Planning Commission

Regular Meeting Agenda
August 12, 2024 | 6:30 PM
Peachtree City City Hall

SUBJECT: Conceptual Site Plan and Building Elevations, Take 5 Oil & Coffee Shop, 2714 HWY 54 W

SUBJECT: Landscape Plan, Gerresheimer, 650 HWY 74 S

NOTE:
GC AND OWNER TO COORDINATE COLOR MATCHING OF MATERIALS WITH TAKE 5
CONSTRUCTION MANAGER, PRIOR TO ORDER OF MATERIALS AND CONSTRUCTION

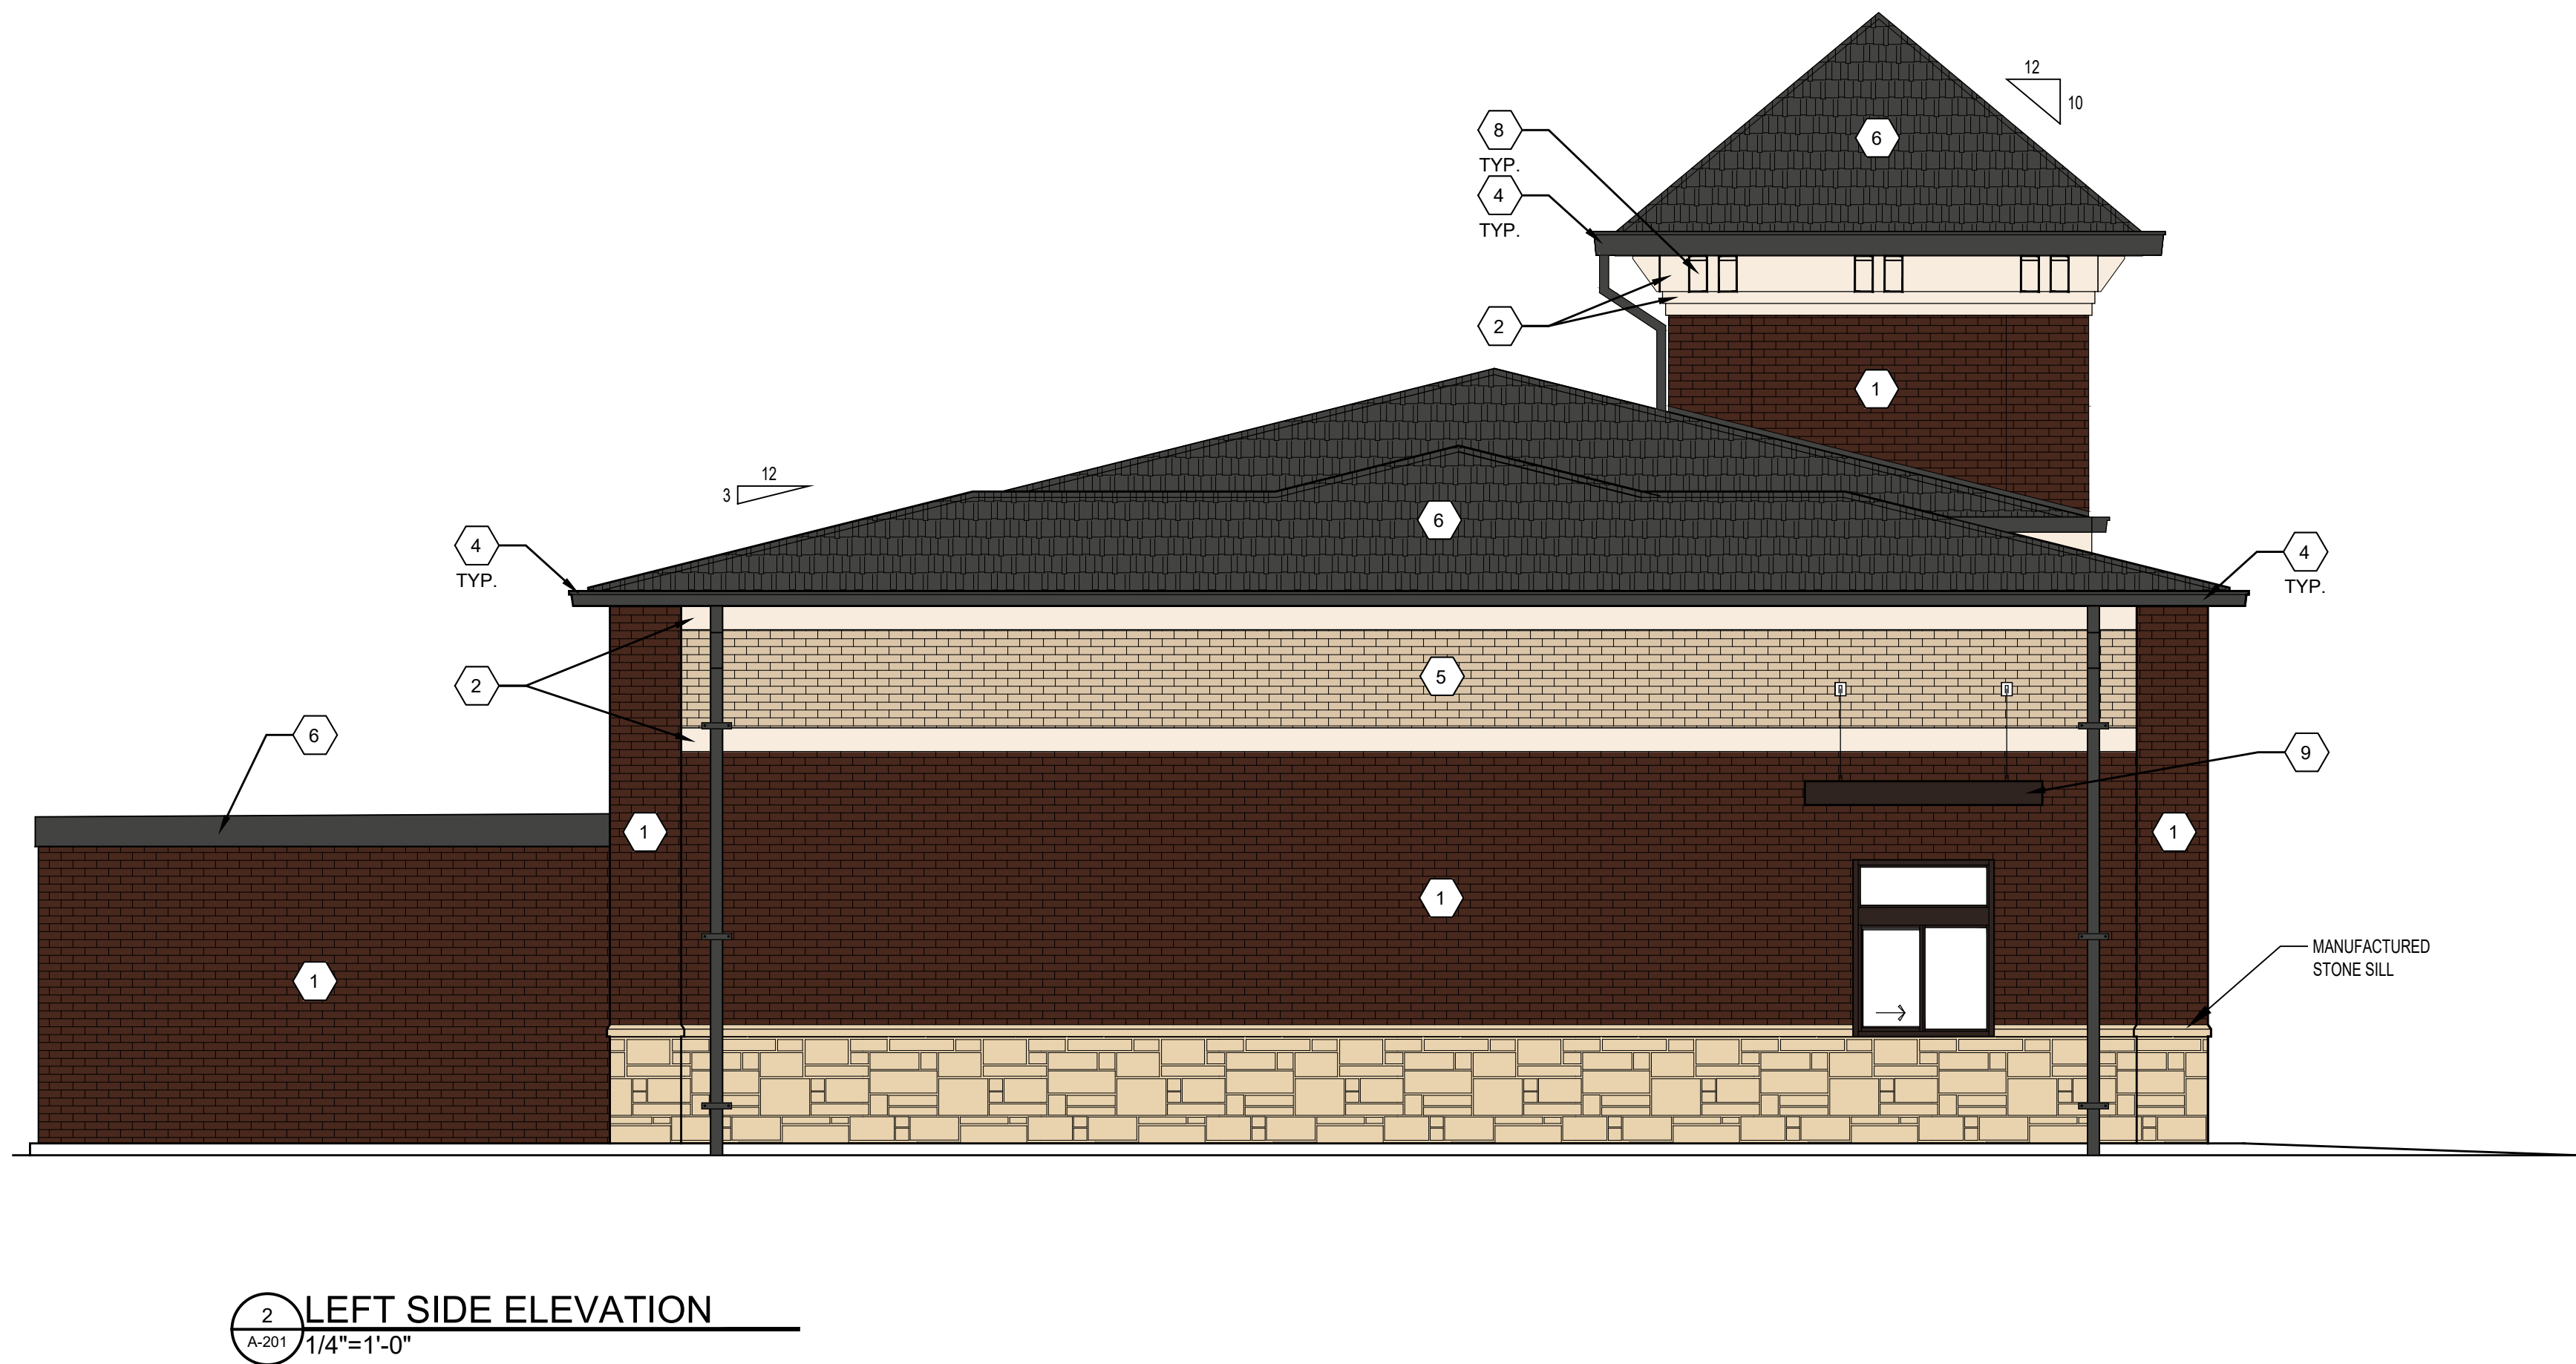
The proposed building elevations are very similar to the approved elevations. The secondary brick has been changed from Portsmouth, a reddish colored brick by Triangle Brick Company, to Ansley Park, a buff colored brick by Cherokee Brick. The Design Guidelines specify Medium Buff by Acme Brick, which is no longer available, or something similar for an accent brick. Since Ansley Park is a buff color, staff feels it is an acceptable replacement.

The only other proposed change is the roofing material. Instead of the approved charcoal gray, standing seam metal roof, an architectural asphalt shingle roof of the same color is proposed. Asphalt shingles are permitted by the Design Guidelines.

The proposal includes the following color palette (the changes are highlighted in bold):

- Primary Brick - Triangle Brick Company, Cambridge
- **Accent Brick - Cherokee Brick, Ansley Park**
- Stone Wainscot - Reading RockCast, Creme Buff
- Accent Moulding - Aztek Exterior Trim, Soft White
- **Roof - GAF Timberline HDZ Shingles, Charcoal**
- Trim and misc. - painted Sherwin-Williams #2927, Weathervane

Staff is of the opinion that the proposed plan and building elevation modifications meet the City ordinances and the GA 54 West Design Guidelines and recommends approval.

LANDSCAPE PLAN
/ TREE PROTECTION PLAN

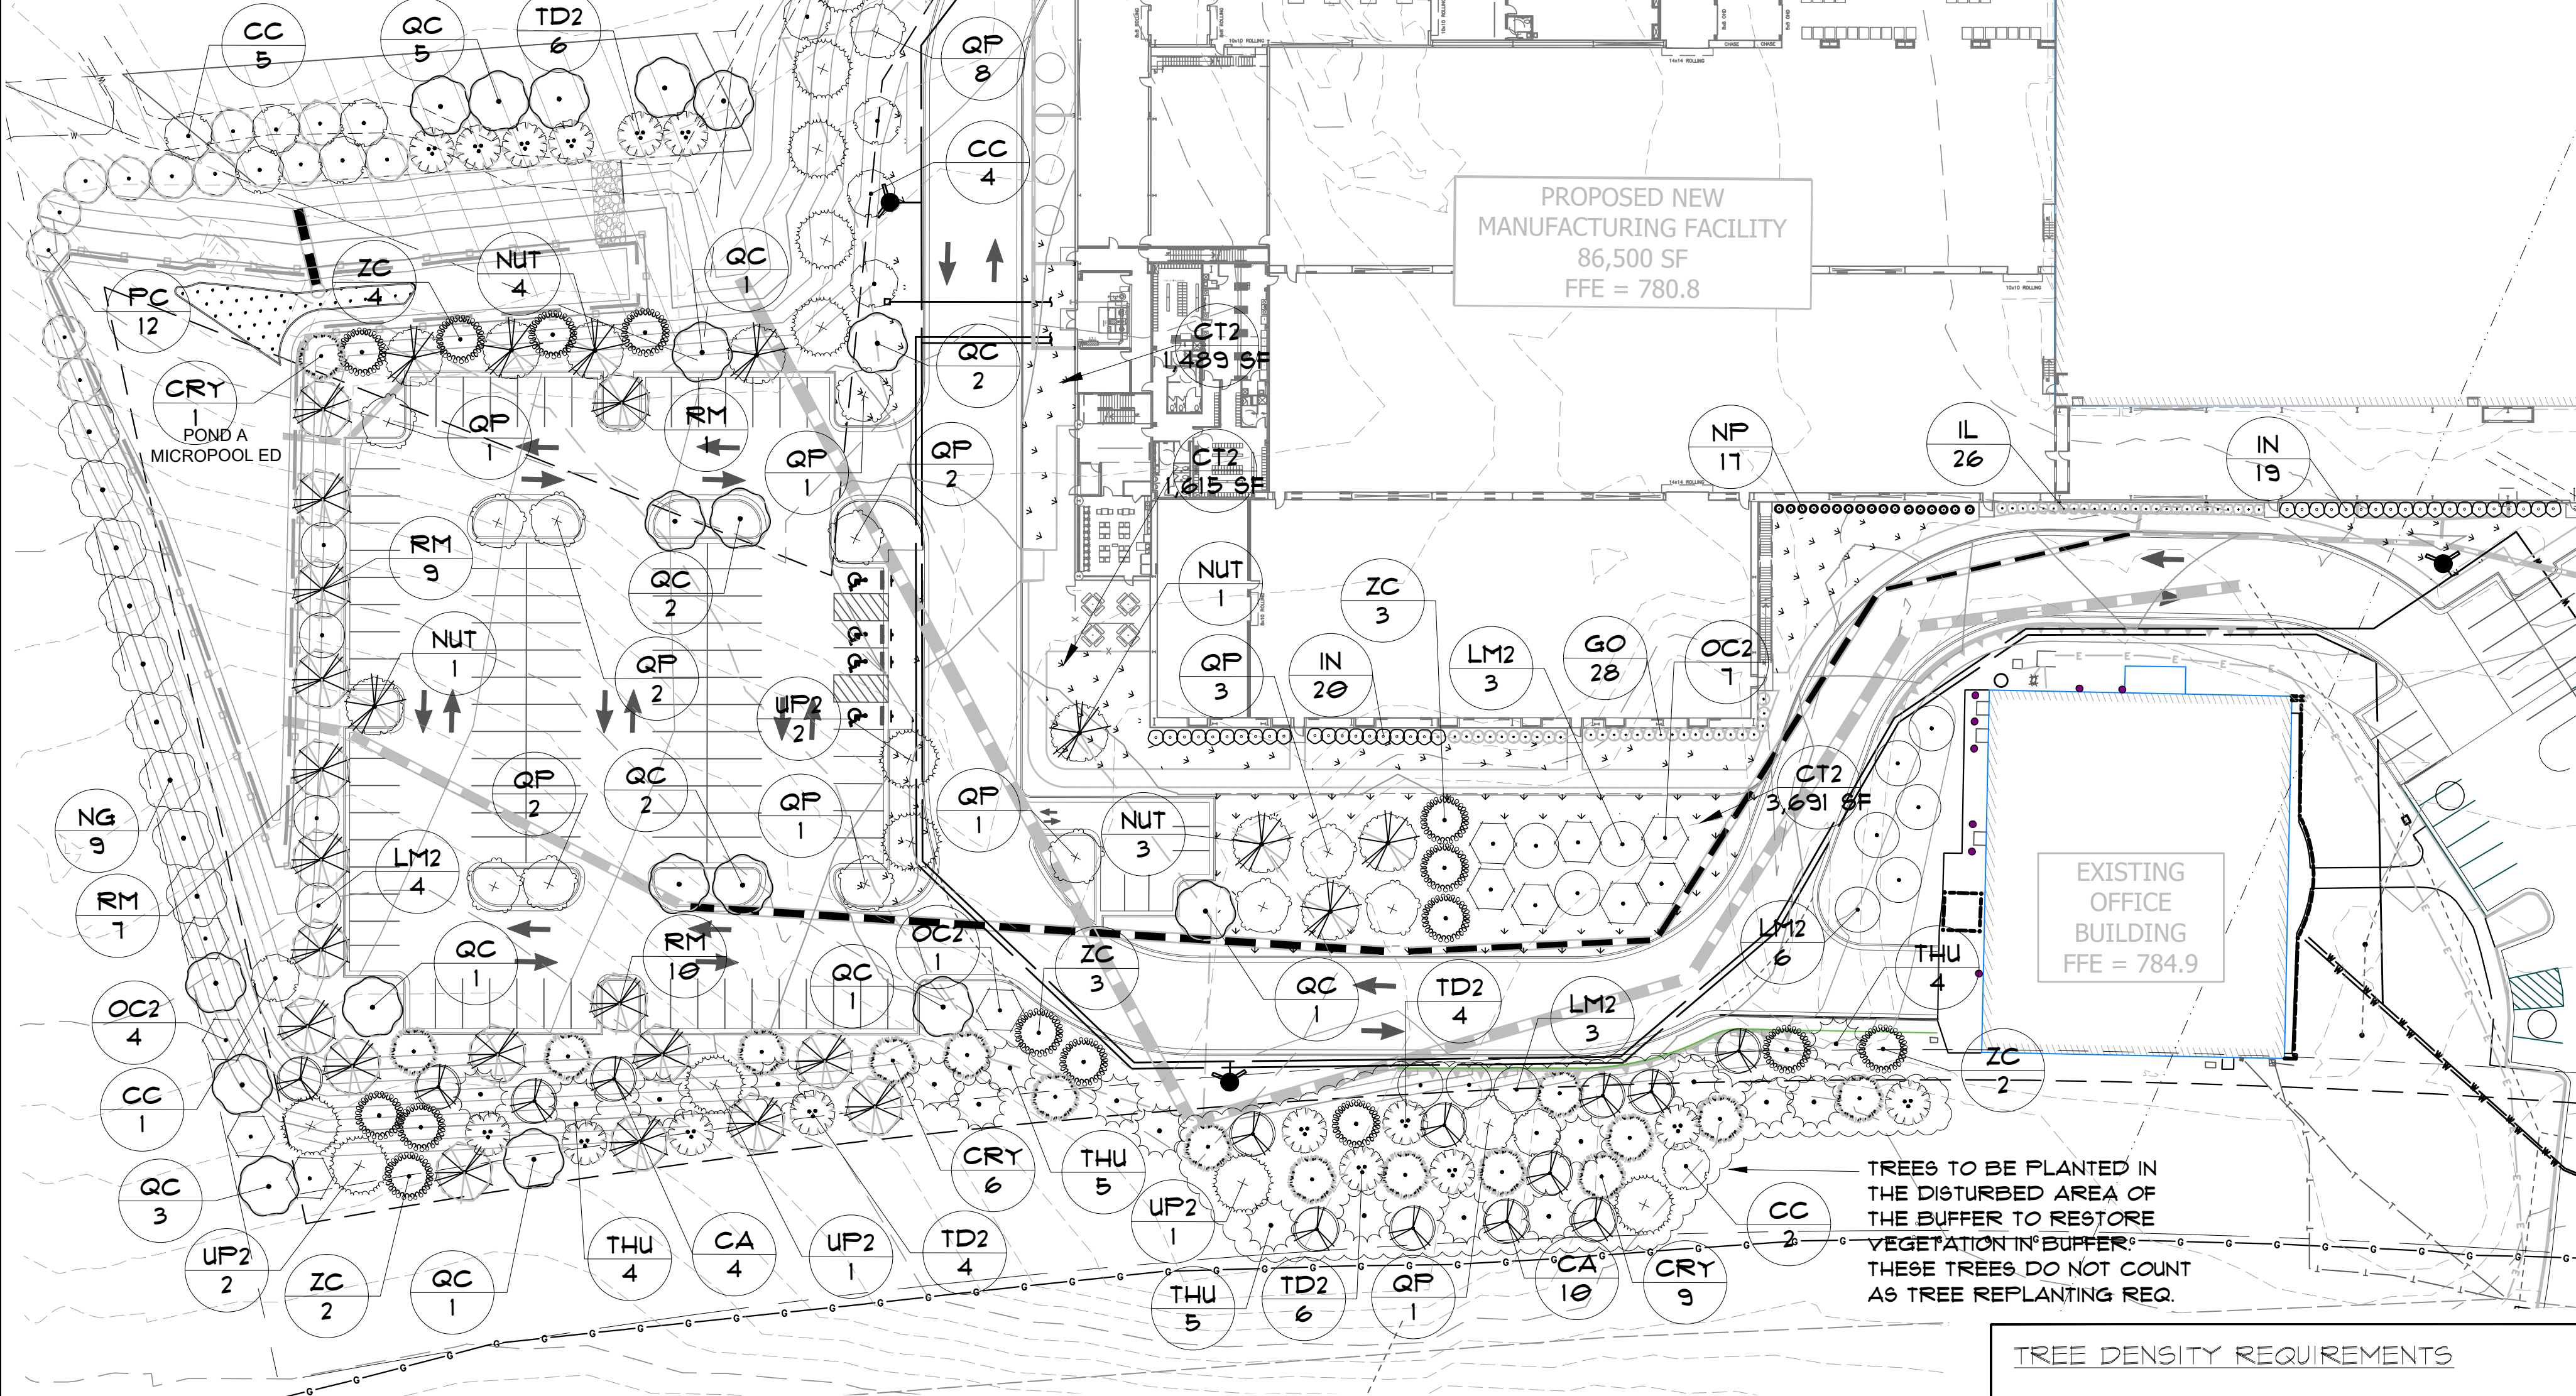
Gerresheimer has submitted a landscape plan for the industrial expansion project located at 650 HWY 74 S. Based on the amount of impervious surface for the expansion (182,421 SF), which includes buildings, drives, parking area, and sidewalks, the landscape ordinance requires at least 546 caliper inches of canopy trees and 364 inches of understory trees.

The applicant is requesting to use the tree fund alternative compliance option permitted in section 1114.5 of the Land Development Ordinance (LDO). Per the ordinance, once all the canopy and understory trees that can be reasonably planted on a project site are provided, the remaining trees can be considered for alternative compliance. No more than 50% of the required caliper inches of canopy and understory trees can be met using this alternative compliance method. It is the opinion of staff that the project site has been designed to be planted to its fullest capacity and therefore qualifies for alternative compliance (see table below).

A portion of the 60-foot tree-save/landscape buffer along HWY 74 was removed for the construction entrance. Gerresheimer is proposing to replant the buffer with a variety of

evergreens and hardwoods including Arborvitae, Cryptomeria, Bald Cypress and American Hornbeam. The replanted buffer area does not count towards the tree requirements.

Staff is of the opinion that the proposed landscape plan for the Gerresheimer Expansion project meets the requirements of the City ordinances using the tree fund alternative compliance method and recommends approval.
